19.2 PLANNING AND ENVIRONMENT COURT APPEAL 339 OF 2018 - HOSGOOD COMPANY 3 PTY LTD & DPK INJECTION PTY LTD (MCU013949 MATERIAL CHANGE OF USE FOR A DUAL OCCUPANCY AT 2 STARKEY STREET, WELLINGTON POINT)

PURPOSE

The purpose of this report is to provide an update to Council on the abovementioned appeal and to seek direction on the current offer to settle.

STARKEY ST
SITE PLAN
SCALE 1:200

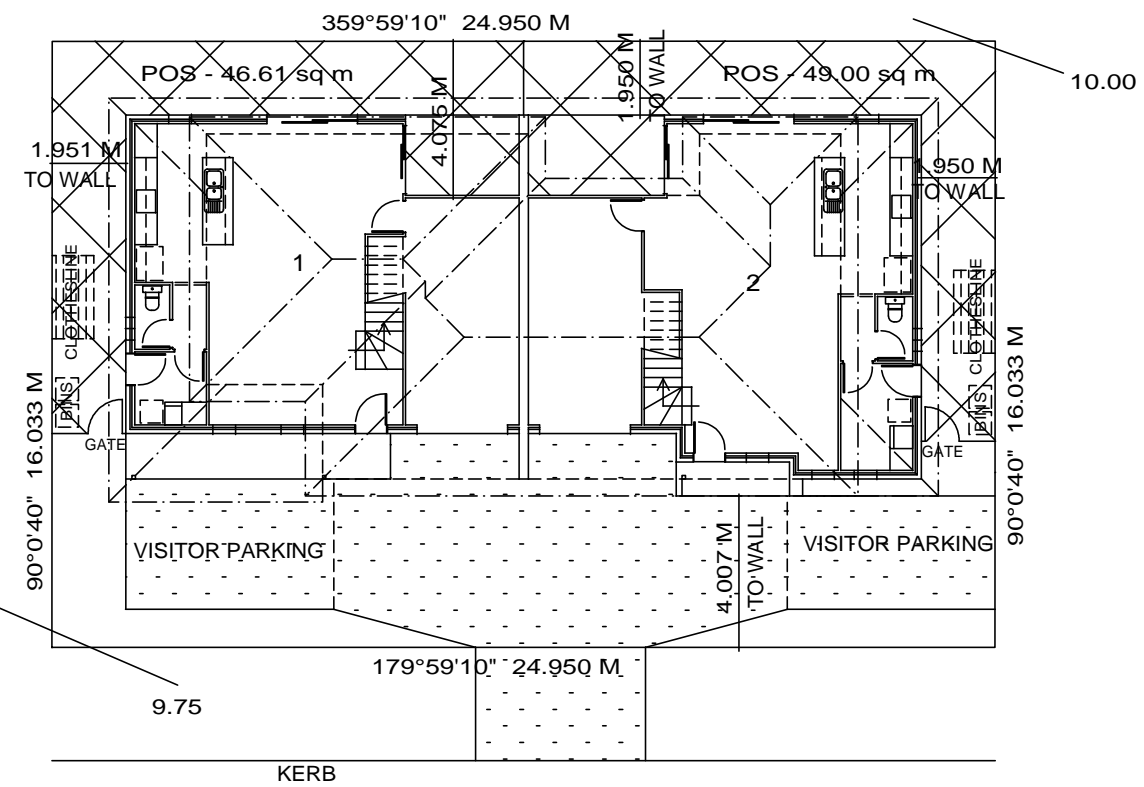
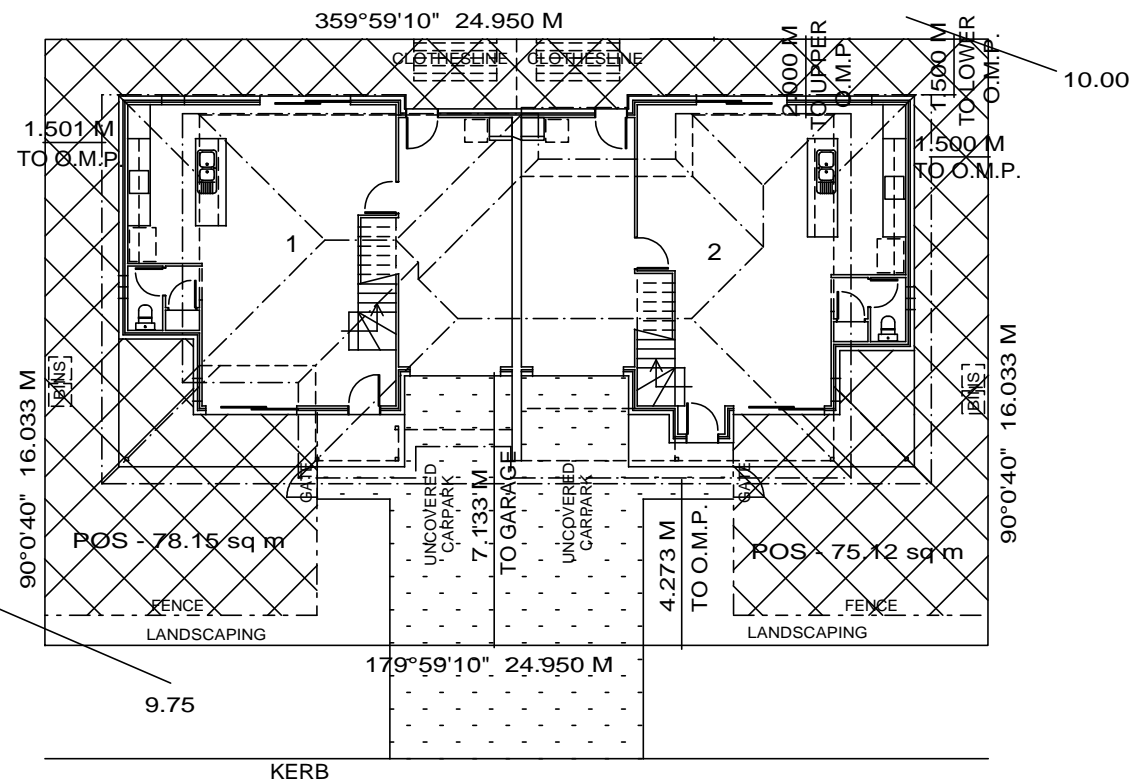
The layout of the parking and the required manoeuvring area results in very dominant concrete hardstand for the majority of the front of the site. This is not consistent with the character of the area which is comprised of landscaped front yards. The proposed landscaping is insufficient to appropriately screen the hardstand, and the visual impact of this will likely alert people to the higher density use of the site.
- **Amenity**

landscaping to contribute to a pleasant, safe and attractive living environment. With regard to the streetscape and amenity concerns raised relating to the extent and visibility of considerable hardstand, it is noted that the alternative layout has substantially reduced these concerns. The reduction in hardstand generally, and the increase in landscaping beside the driveway is considered a welcome change and improvement to the streetscape. The improvements go beyond what Council could reasonably expect on the site if it were to be developed for a single dwelling house.

<p>24. Plant the frontage and driveway landscaping strips at an average density of one plant per square metre, comprising a mix of trees, shrubs and groundcovers. Within this mix, plant at least two tree species.</p> <p><i>Advice: Suggested plant spacing – groundcovers at 600mm-1.0m, shrubs at 2.0-2.5m, trees at 5.0m.</i></p>	<p>Prior to the use commencing and ongoing.</p>
<p>25. Provide organic mulch to all garden bed areas at a minimum depth of 100mm.</p>	<p>Prior to the use commencing and ongoing.</p>
<p>26. Pay to Council a monetary contribution for street tree planting for two (2) street trees. The contribution must be calculated in accordance with the Redlands Planning Scheme Policy 3 Chapter 3 – Landscaping and must be paid at the rate current at the time of payment under Council's Fees and Charges Schedule. The current rate is \$177 per tree (2018/2019 Financial Year).</p>	<p>Prior to the use commencing.</p>

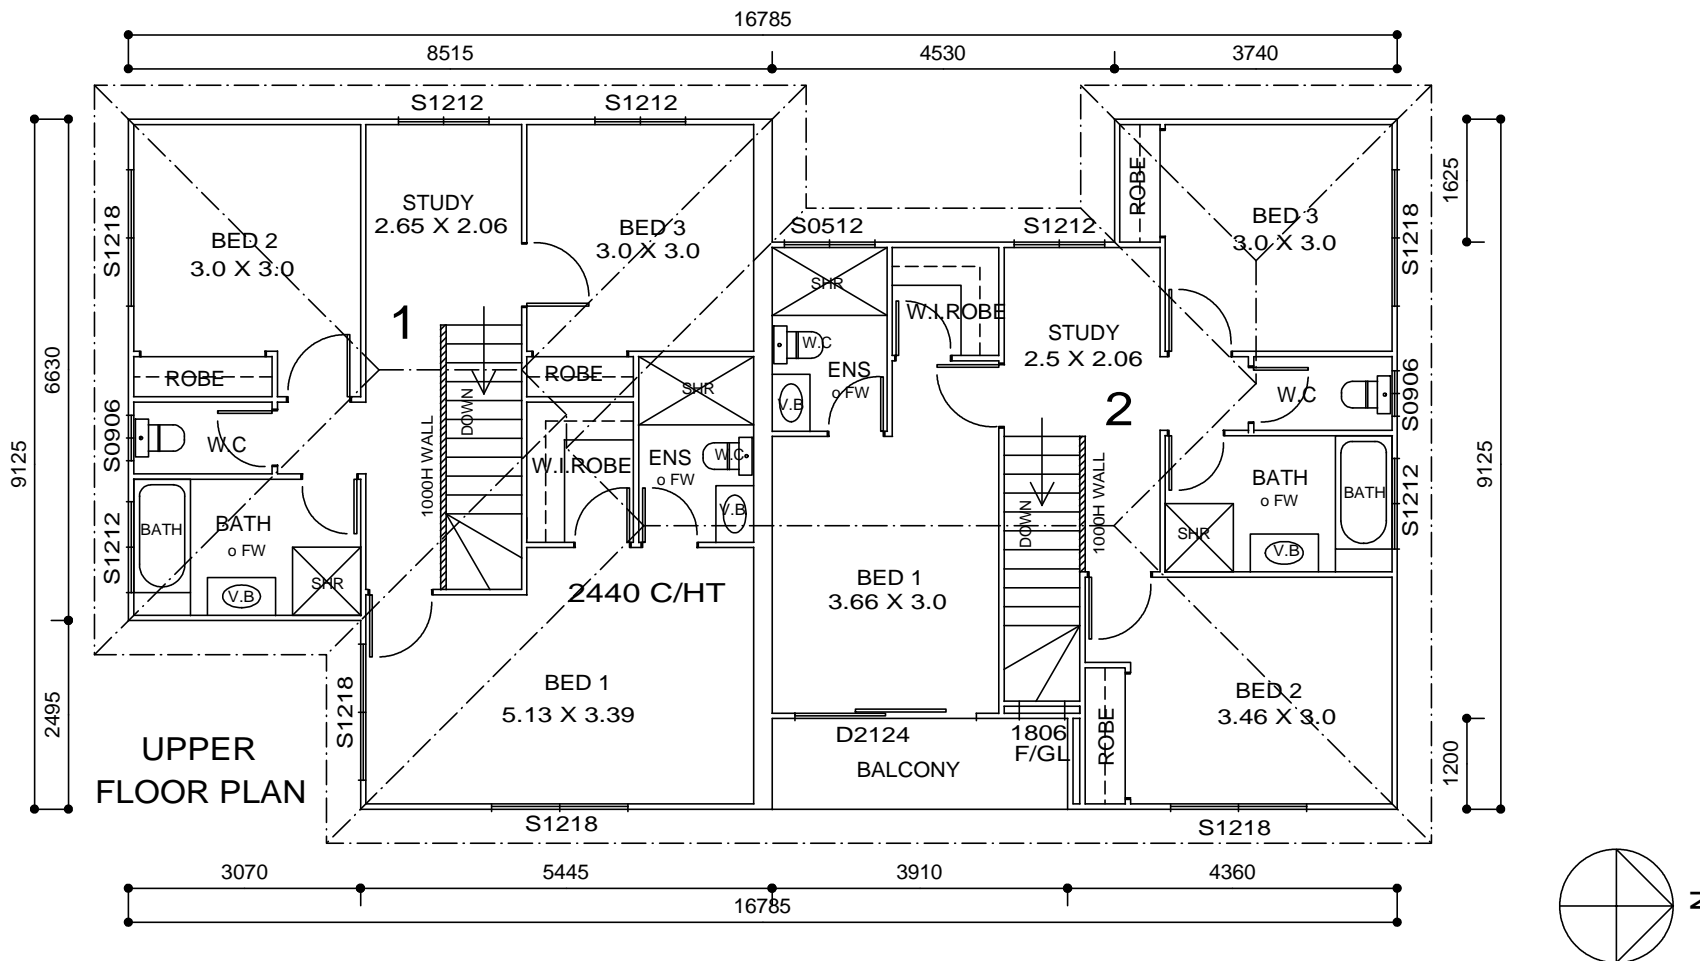
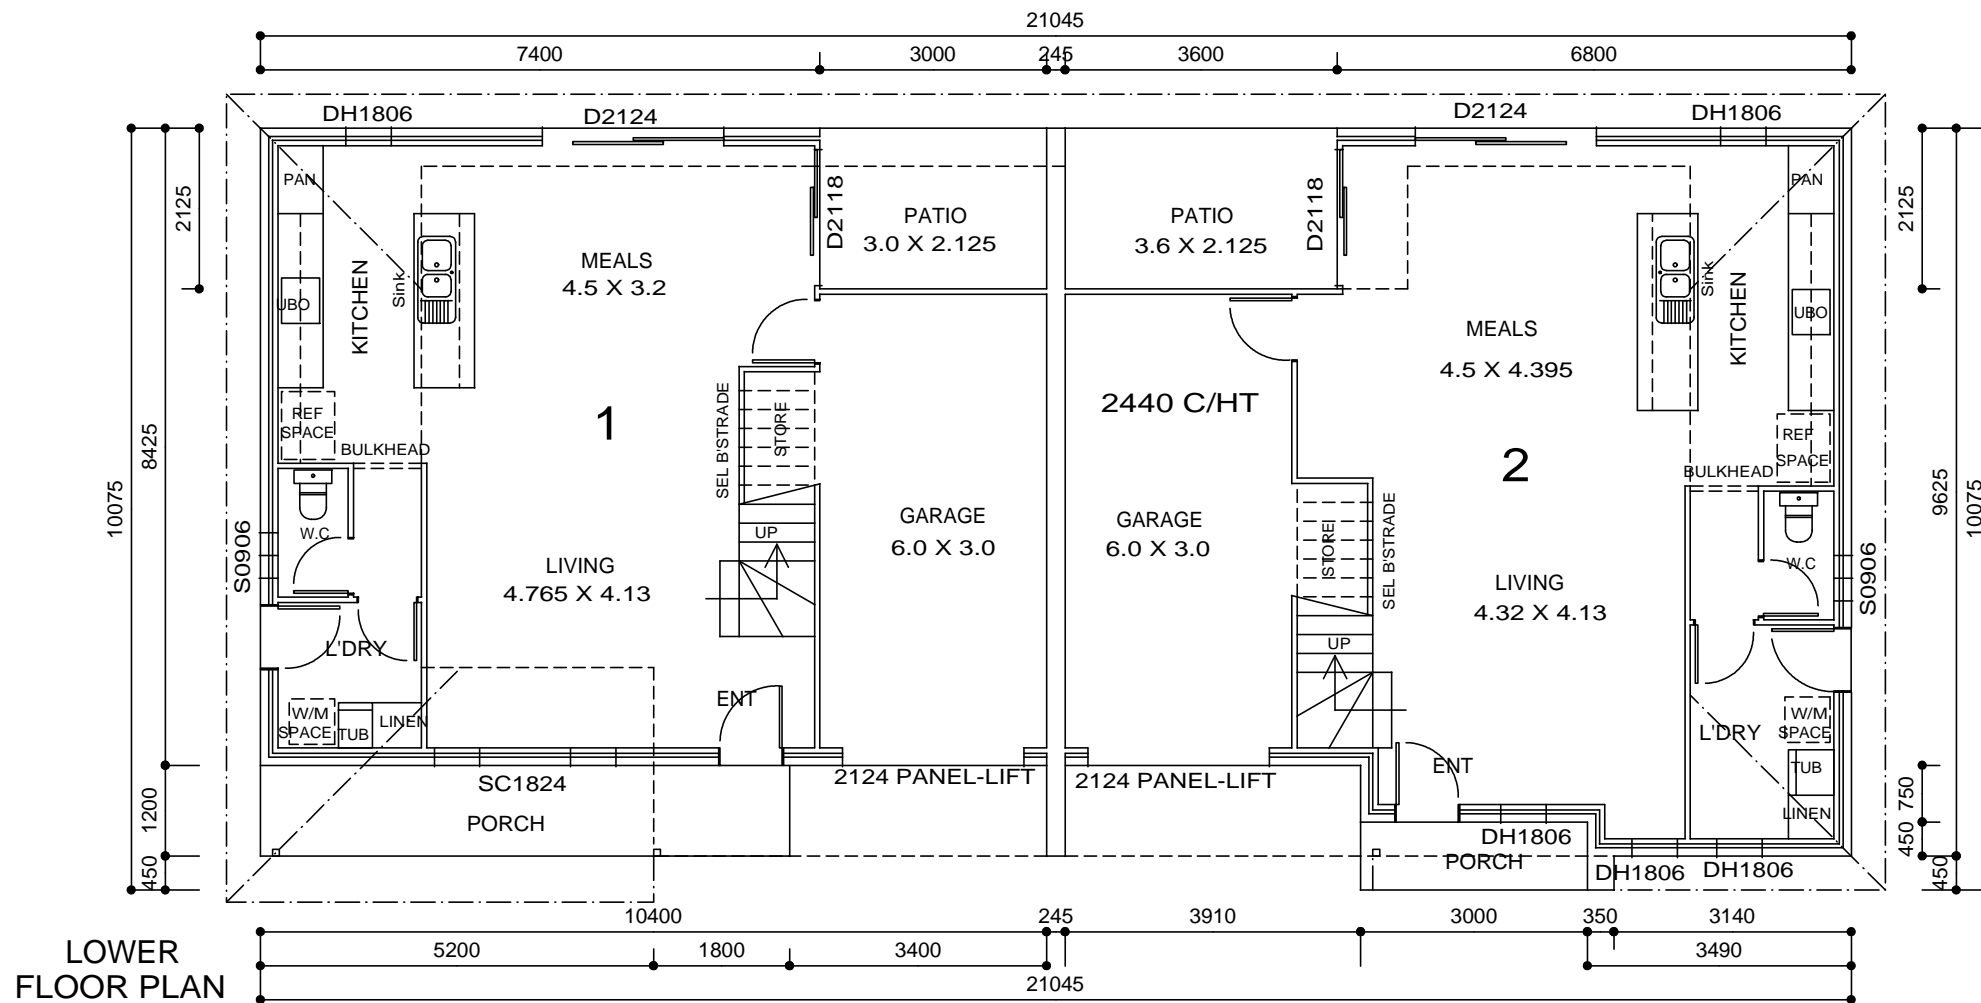
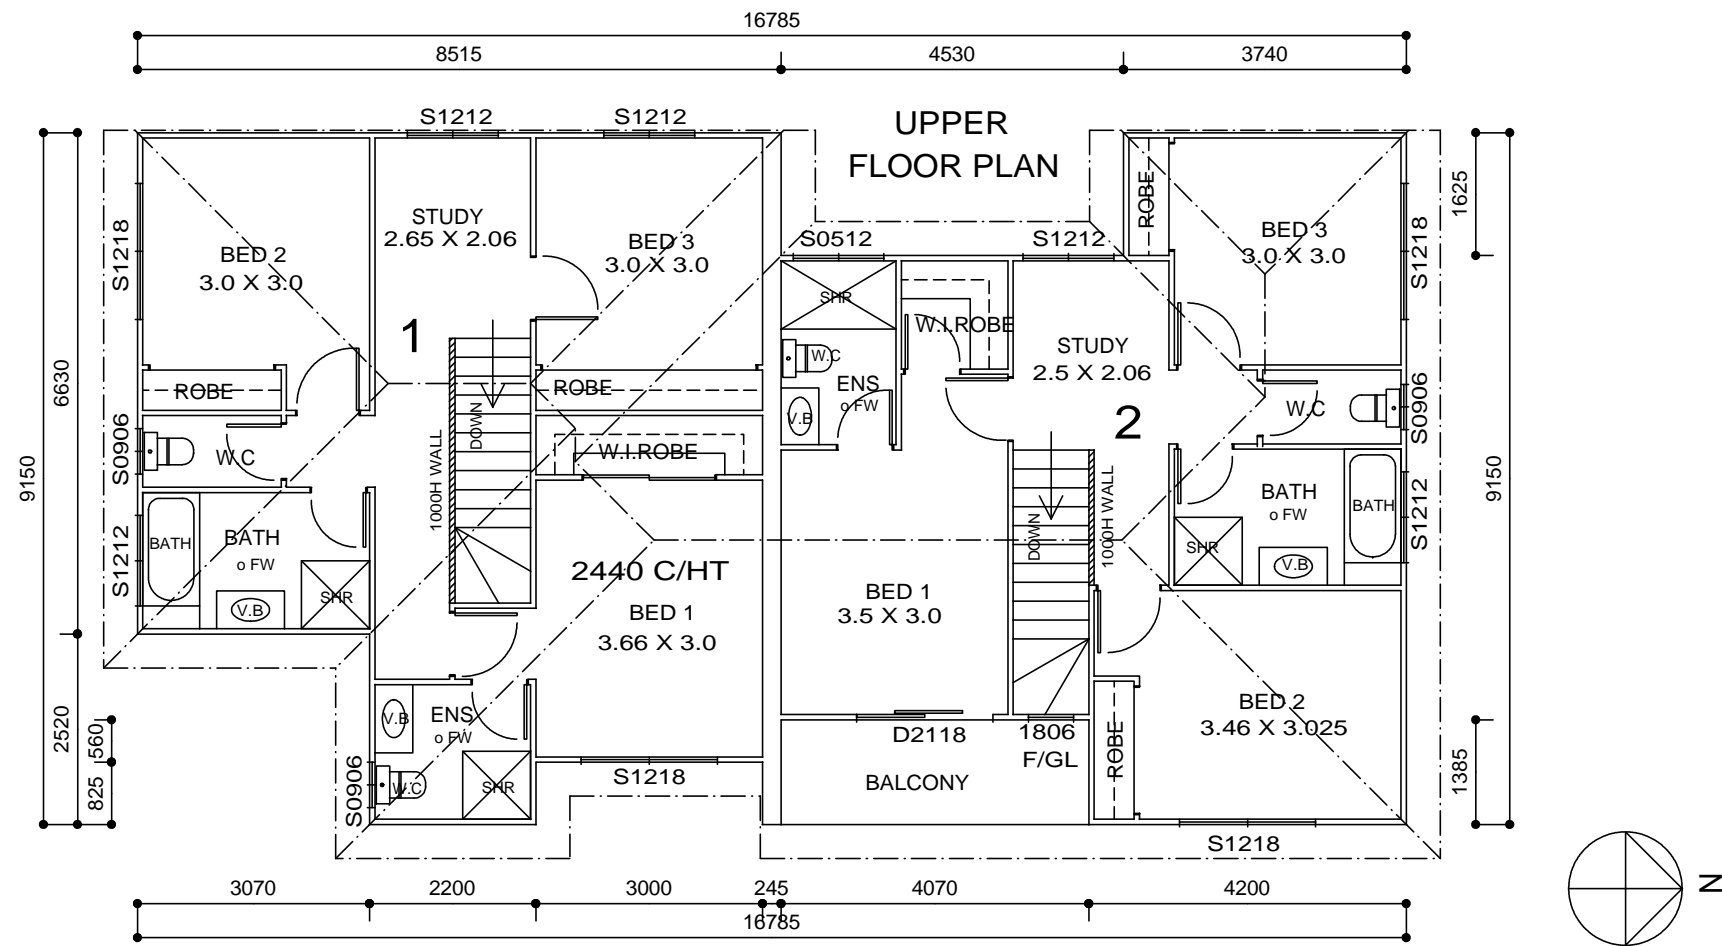
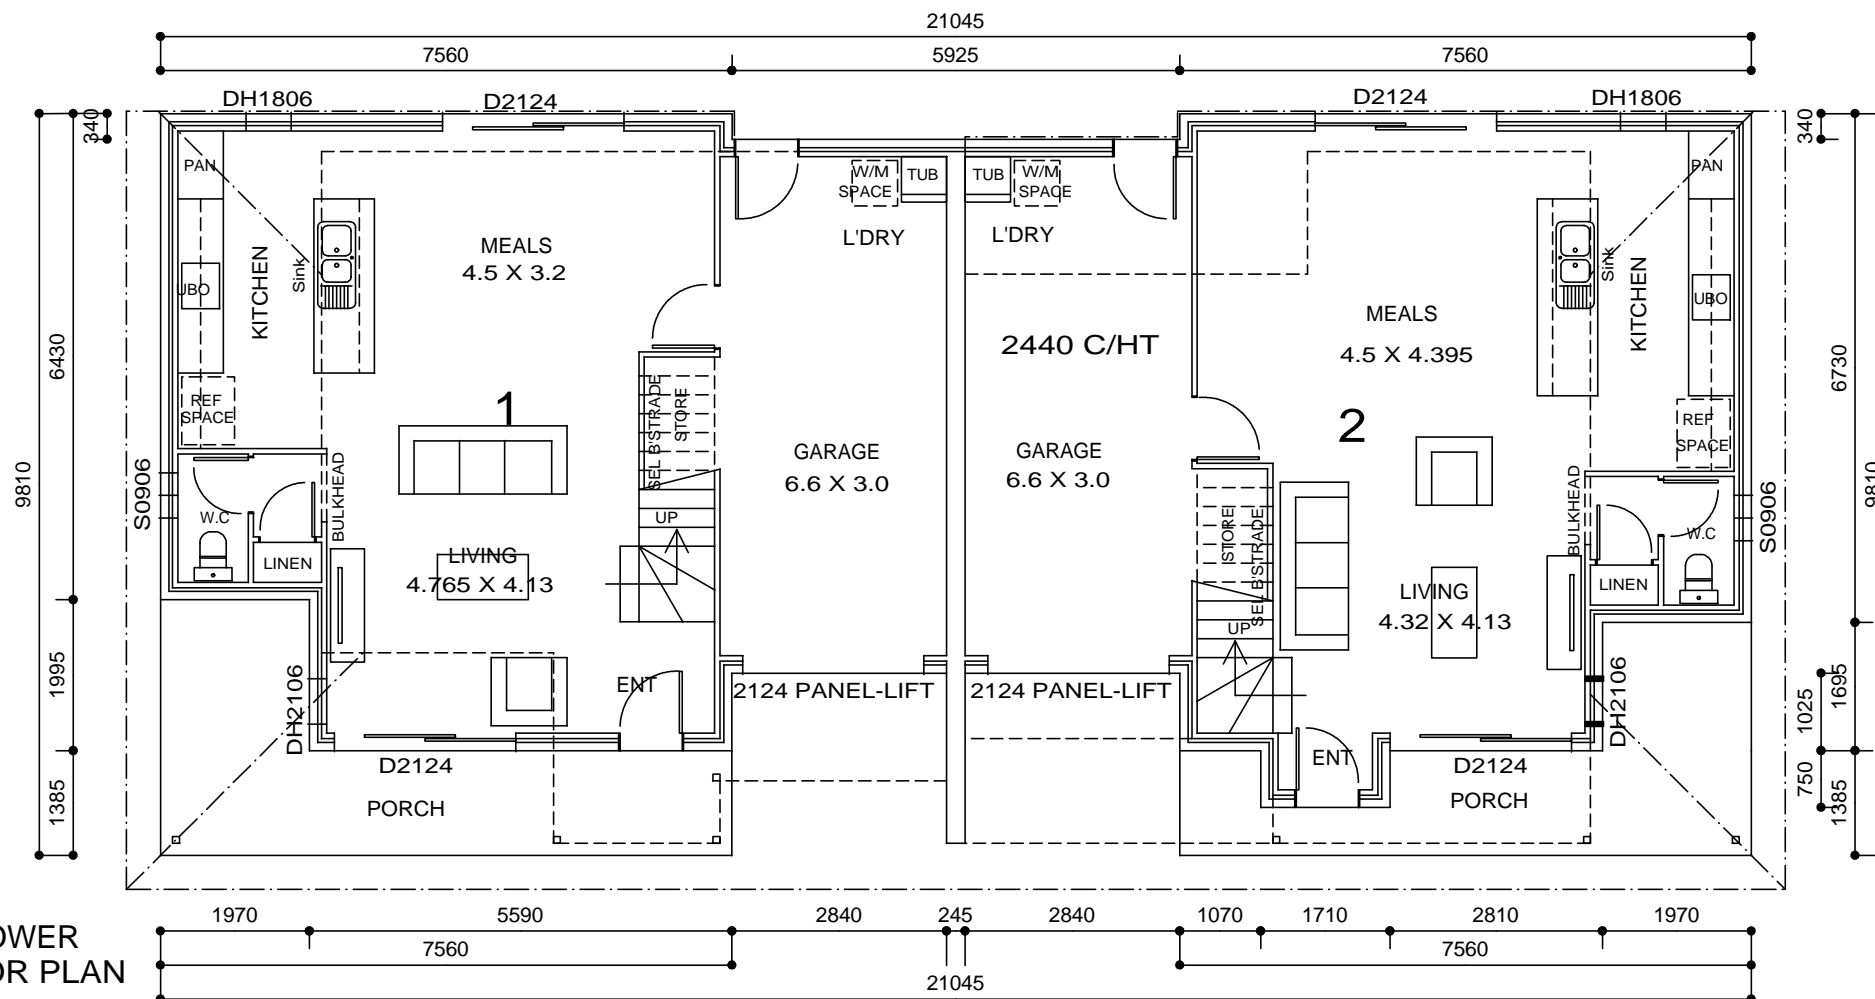
The design and articulation of the building to present the use as one dwelling is undermined by the prominent visual positing of the front doors. Both doors will be clearly visible from Starkey Street. Through minor design tweaks is it easy to move one of the doors to the side façade of the building and still have clear and easy access to the living areas of the dwelling units. A recommended condition of settling the appeal will be to ensure that one of the front doors is relocated and not visible from the street elevation.

<p>7. The private open space (POS) identified on the approved site plan must be maintained for the private and exclusive use of the corresponding unit.</p>	<p>Prior to the use commencing and ongoing.</p>
<p>8. Relocate the front door of either Unit 1 or 2, so that that only one front door is visible on the front elevation.</p> <p><i>Note: The purpose of this condition is to maintain the appearance of a single dwelling house from Starkey Street.</i></p>	<p>Prior to the use commencing and ongoing.</p>
<p>9. Amend the garage design in accordance with the amendments in red marked on the approved plans for both units as follows:</p> <ul style="list-style-type: none"> • The finish of the wall dividing the garages must match the finish of the ground floor façade, whether brick or render. <p><i>Note: The purpose of this condition is to maintain the appearance of a single dwelling house from Starkey Street.</i></p>	<p>Prior to the use commencing and ongoing.</p>
